PROVINCIAL ELECTRICITY AUTHORITY

SINGLE-PHASE TRANSFORMERS FOR 22 kV and 33 kV 50 Hz DISTRIBUTION SYSTEMS

Specification No. RTRN-047/2561

**เอกสารเพิ่มเติมแนบท้ายรายละเอียดสเปค
(ADDENDUM)**

อายุของรายงานผลการทดสอบ Type test and Short-circuit withstand test

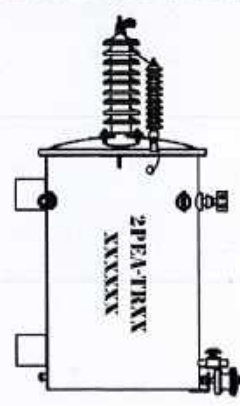
ให้ใช้รายละเอียดอายุของรายงานผลการทดสอบ Type test and Short-circuit withstand test ที่กำหนดในเอกสารเพิ่มเติม (ADDENDUM) นี้ แทนรายละเอียดอายุของรายงานผลการทดสอบ Type test and Short-circuit withstand test ในหัวข้อ 1e.2 Type test and Short-circuit withstand test

The type test and short-circuit withstand test report of the transformers shall be valid within ten (10) years count from the issued date in the test reports to the bid closing date.

อายุของรายงานผลการทดสอบ Type test and Short-circuit withstand test

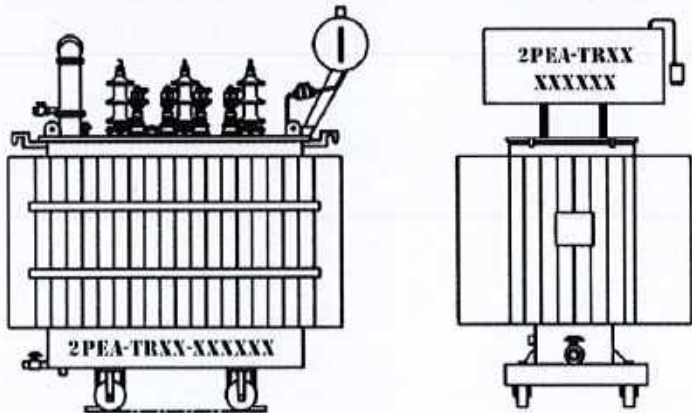
ให้ใช้รายละเอียดอายุของรายงานผลการทดสอบ Type test and Short-circuit withstand test ที่กำหนดในเอกสารเพิ่มเติม (ADDENDUM) นี้ แทนรายละเอียดอายุของรายงานผลการทดสอบ Type test and Short-circuit withstand test ในหัวข้อ 1e.2.3 Type test and short circuit test report

The type test and short-circuit withstand test report of the transformers shall be valid within ten (10) years count from the issued date in the test reports to the bid closing date.
